Re: Mining Plan Federal Potash Lease UTU-087909-UTU-087818 response to Mining Plan submittal on May 9, 2008.

BLM received and reviewed your Mining Plan dated May 9, 2008. As a result of our review, BLM has some concerns with the bonding portion of the Mining Plan. Although DOGM has accepted the bond amount in the document, BLM requires an additional financial guarantee:

**Photo 1. Pond V berm on the far left and the ditch with berms on the right.**

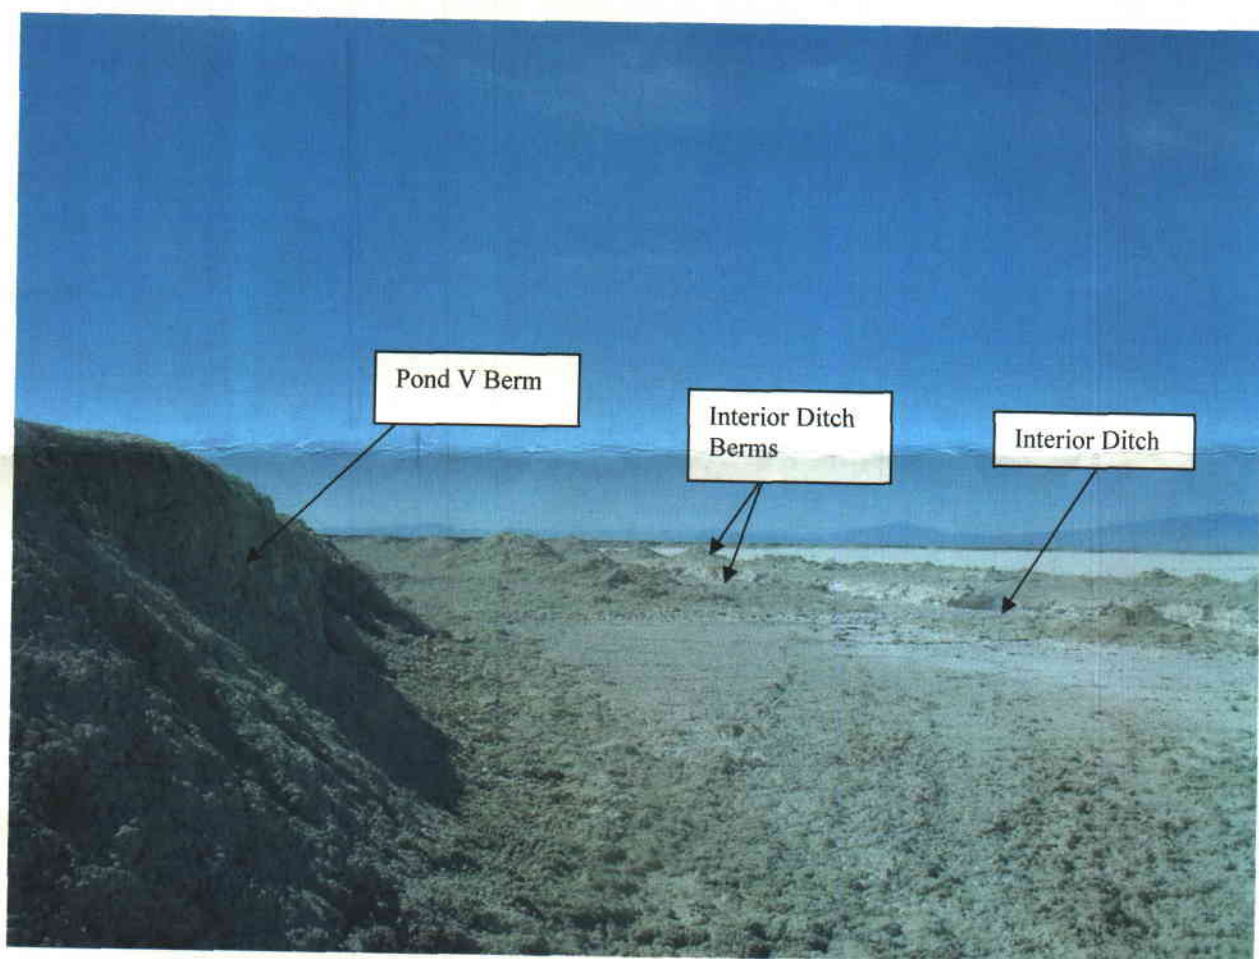
1. Drawing 6.8 shows the reclamation of the old Pond V system. The drawing indicates that on the south side of the pond system a ditch will be reclaimed leaving the berm unreclaimed. On September 5, 2008 BLM took photographs of the south east side of the Pond V system showing that there is both a ditch and berm (see photo 1, below). There is approximately 8.5 miles (including section 16) of berm that has not been accounted for in the bond calculation. This equates to approximately \$296,000 based on your cost estimates (\$17,375 for 1/2 mile).

Figure 2 ROW ditch/berm on Google Earth

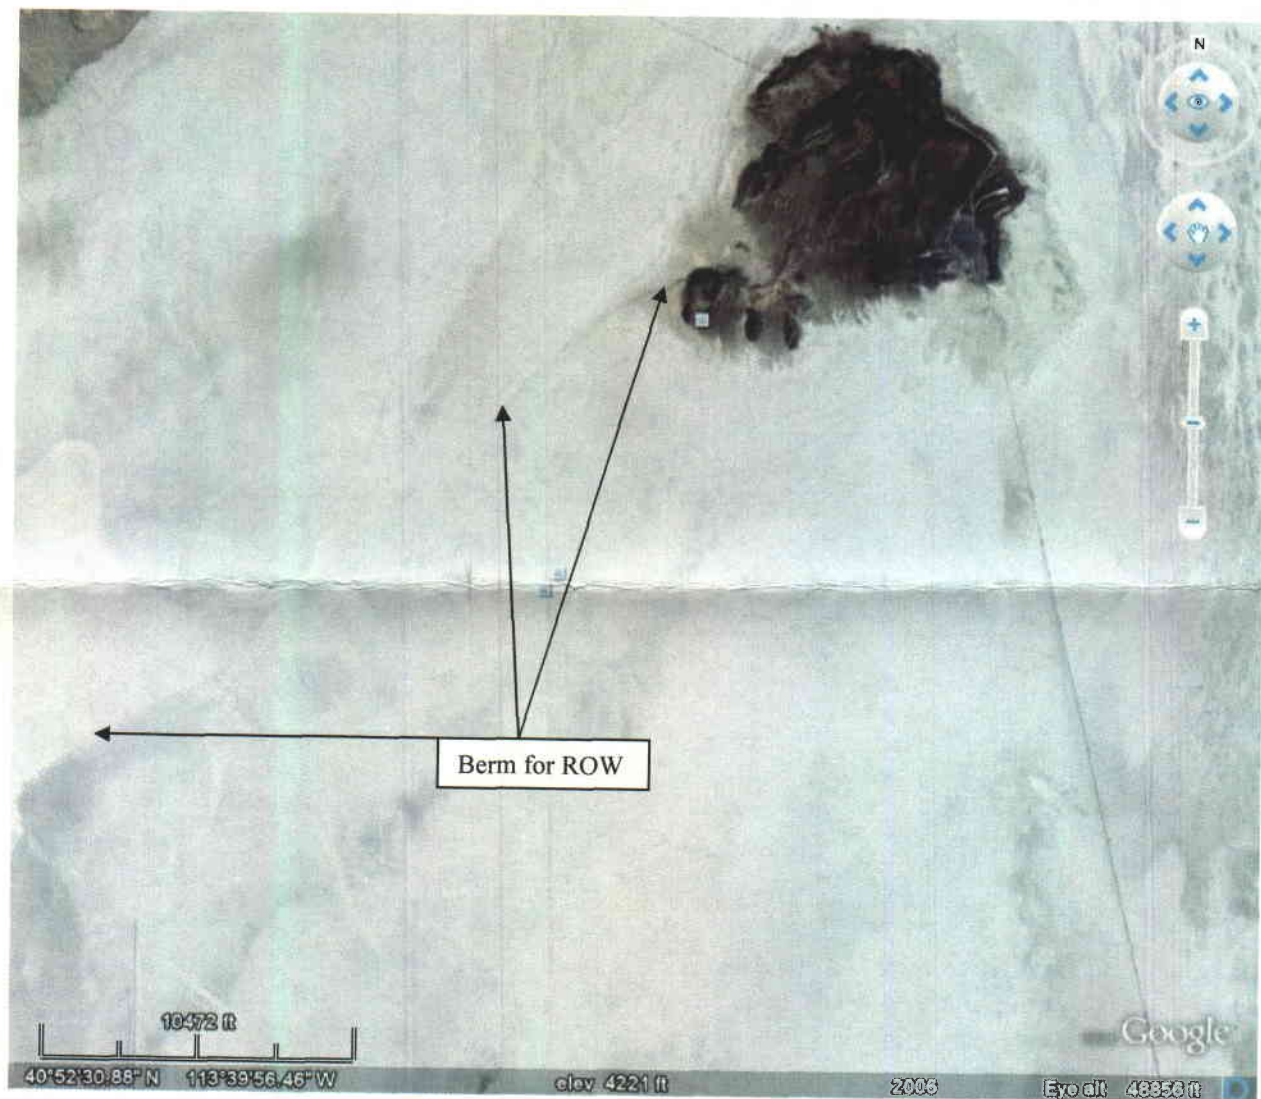
3. The Right of Way (ROW) 074087 for the Salt Lay Down project. Is part of the mine plan and needs to be addressed in the reclamation plan. None of the maps include this ROW, but the ditch and berm can be seen (on photos 2 and 3 attached). From these photos we estimate the length of the ditch and berm to be approximately 5.7 miles. We estimate that the volume of material is about the same as the north ditches (\$4261 per 1/2 mile) which results in a reclamation cost of approximately \$49,000.
